ADOPTION DE PUBLICATIONS DE L'OHI
SPECIFICATIONS DE PRODUITS BASEES SUR LA S-100
PHASE 1 – S-101, S-102, S-104, S-111, S-129

Réponses des présidents des groupes de travail et des équipes de projet concernés, du président du HSSC et du Secrétariat de l'OHI aux commentaires des Etats membres sur la LC 39/2024 de l'OHI (en anglais uniquement)

**MEMBER STATES' RESPONSES TO IHO CL 39/2024 AND COMMENTS
FROM THE WORKING GROUP and PROJECT TEAM CHAIRS, IHO SECRETARIAT**

S-101, Ed. 2.0.0	Operational Product Specification
-------------------------	--

Figure 4-10 – Dataset loading – scenario 4

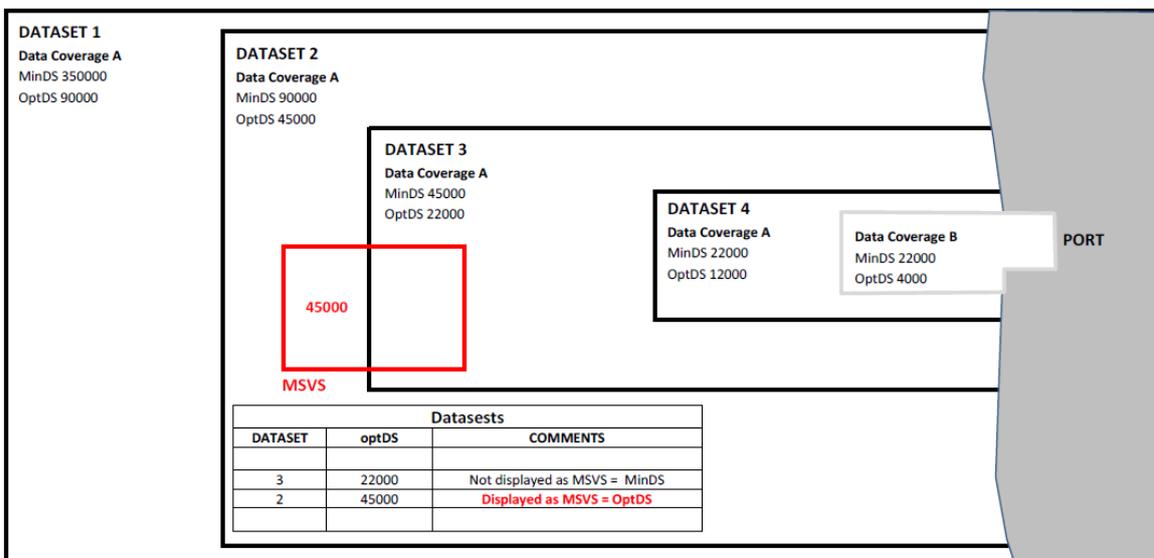
- 3) Product Specification - Add the attached Diagram to the end of Section 4.7.2 as a new Figure 4.10 and amend 2nd paragraph to read 'Figures 4-7 to 4-10 below are ...!'

Please note that all other Figures in the PS will have to increase their number by one.

The S-101PT Chair and IHO Secretariat thank Australia for their comments. These proposed changes have been agreed for correction (point 1) and clarification (points 2 and 3) as they enhance the guidance already included. The proposed new Figure 4-10 for the S-101 Main document has been included as Figure 4-9 as this is a better fit within the order of the Figures 4-7 to 4-10 in regard to Mariners' Selected Viewing Scale (MSVS). The changes have been applied for the final operational Edition 2.0.0 of S-101.
